Crystal River Unit 3
Docket No. 50-302
Operating License No. DPR-72

June 14, 2001
3F0601-03

Subject: Crystal River Unit 3 - License Amendment Request #262, Revision 1, and Response to NRC Request for Additional Information RE: License Amendment Request #262, Revision 0, "Alternative Source Term and Control Room Emergency Ventilation System" (TAC No. MB0241)

Figure 2

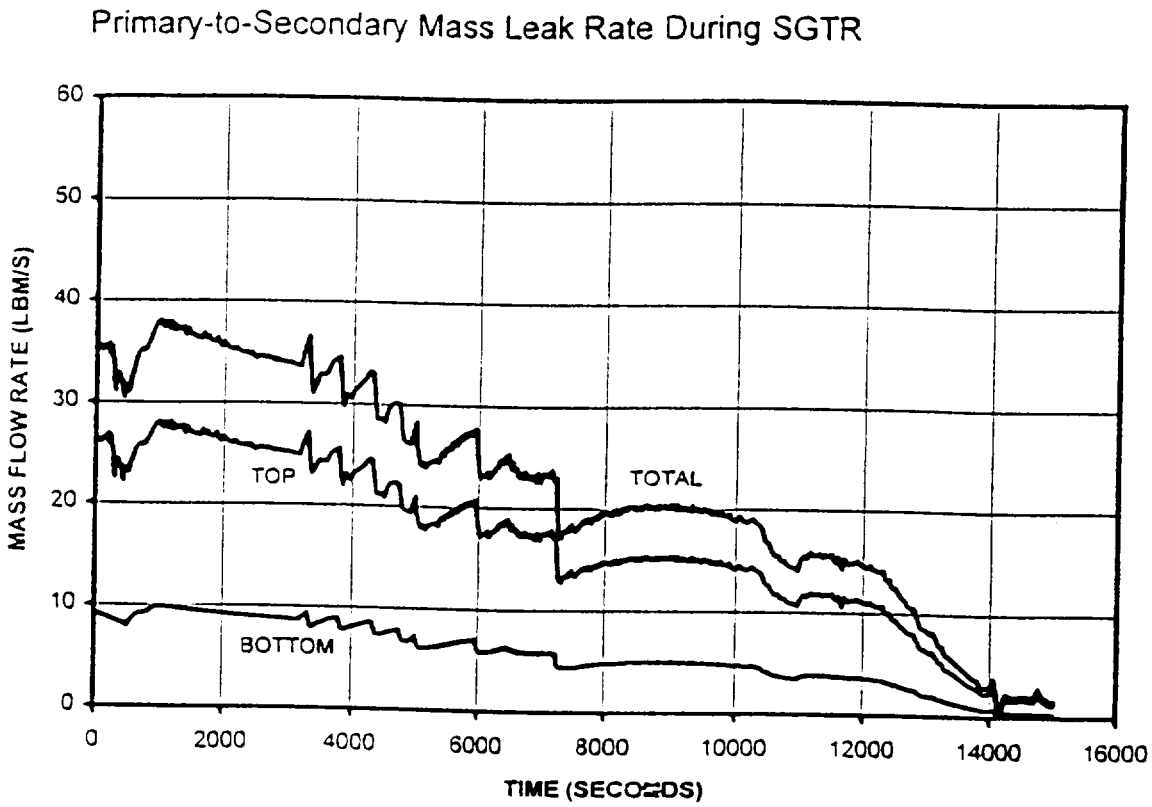
For the iodine spiking releases shown in the tables in Attachment 2 to Appendix E and in Attachment 2 to Appendix L, your submittal explains that they were generated by a thermohydraulic code. Page 8 of Appendix B does explain some of the basis of this determination for the letdown break. Please provide a brief description of the calculational algorithm used by this code. Also provide the volume or mass of primary and secondary releases for the four time periods. These data are needed to assess the acceptability of your assumed releases.

The primary to secondary mass flow rates for the SGTR are shown in Figure 2. Average rates for each of the 4 time periods are approximated as follows:

0-0.13 hrs – 33 lbm/sec (note – releases over this time period are to the condenser and are reduced by a factor of 100)
  0.13 - 0.63 hrs – 36 lbm/sec – released directly to atmosphere with no decontamination factor (DF)
  0.63-1.8 hrs – 30 lbm/sec – released directly to atmosphere with no DF
  1.8 - 8 hrs – Although Figure 2 shows a primary to secondary mass flow for this time period, this flow is into the affected generator, which is isolated at 1.8 hours. Hence, activity in this flow will not be released. The activity being released during this period is only from the assumed 150 gallons/day primary to secondary leak in the unaffected generator, which is assumed to be released directly to atmosphere with no DF.
